Application No. 10/767985 Page 11 Amendment
Attorney Docket No. S63.2B-11023-US01

Amendments To The Drawings:

Remarks

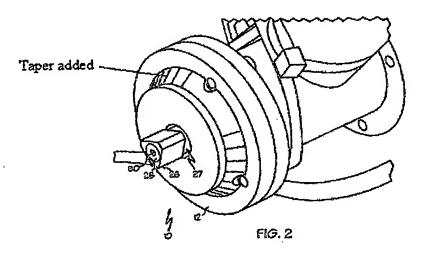
The Office Action objects to the specification and to the drawings.

Figure 2 has also been amended to show the externally tapered head, as shown below. The amendment to Figure 2 is supported by the specification as filed, see page 6, line 10, and the tapered portion is also shown in Figure 3 as filed.

Figure 2 has been amended to show the externally tapered head. See page 6, line 10.

White discloses a device for loading a flexible member 30, such as an imaging core, into a catheter. See Abstract, column 3, lines 32-50, etc. Figure 6 of White is provided below for convenience.

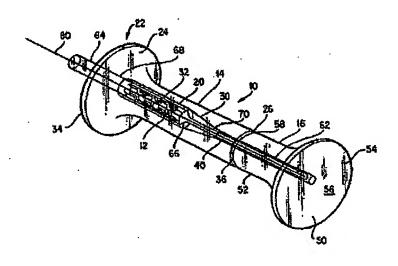
The Office Action asserts that White discloses "an introducer shaft (not labeled in fig. 6) attached to knob (28)." See Office Action page 5, and Figure 6 of White, provided above.

Reference numeral 28 refers to a regulator assembly relevant to the amount of gap 48 between the rollers 12, 14. See column 4, lines 27-60 and Figs. 5-5B.

Applicants assert that the alleged introducer shaft as described in the Office Action does not have an internal lumen for receiving the catheter delivery system, as required by claim 4.
